MODIFICATION TO PREVENT MICRO LOCKUP ON AR3000A

March 1992 - AOR UK Ltd.

Modification for lock-up problem
MICO BOARD R23000A

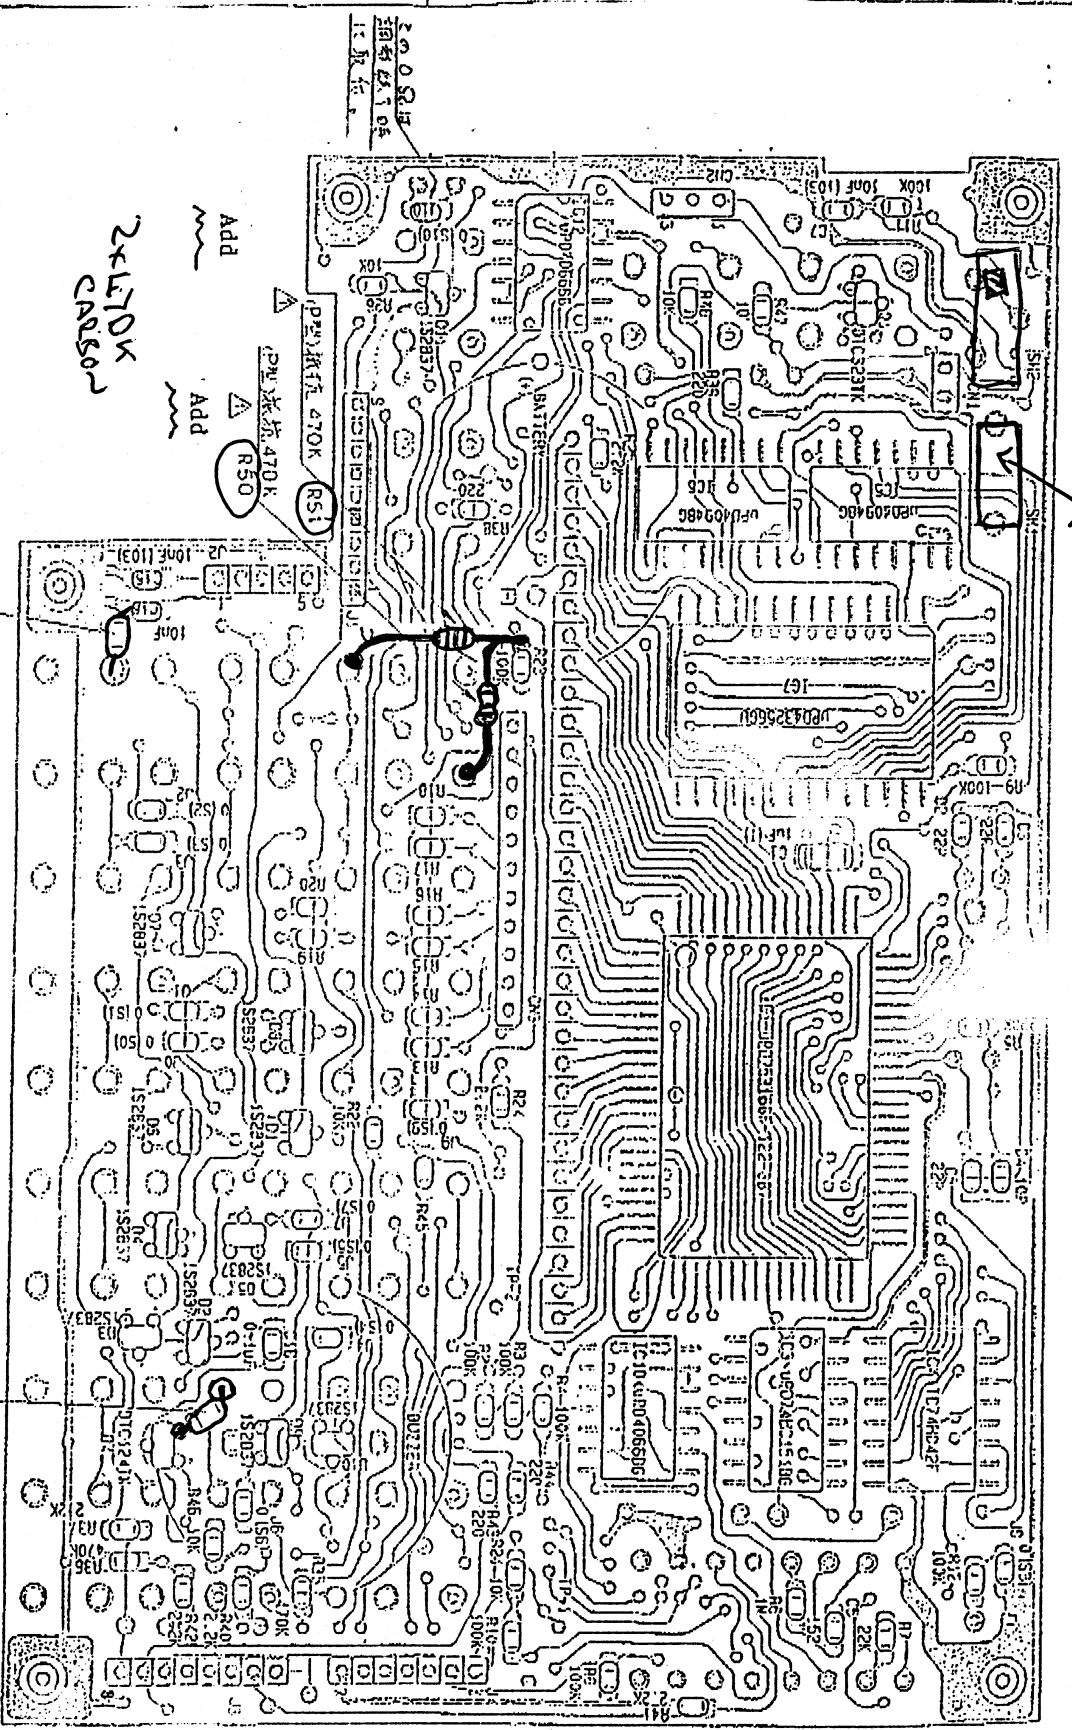
Should you experience frequent microprocessor lockups on the AR3000A receiver due to microprocessor runaway, the following modification may be implemented:

- R50 Add a 470k carbon resistor to the point indicated on the accompanying PCB layout
- R51 Add a 470k carbon resistor to the point indicated on the accompanying PCB layout
- R49 Add a 470k chip resistor to the point indicated on the accompanying PCB layout
- R52 Add a 470k chip resistor to the point indicated on the accompanying PCB layout. You will first need to remove the black bleeder unit by de-soldering the two connections from the LCD side of the PCB.
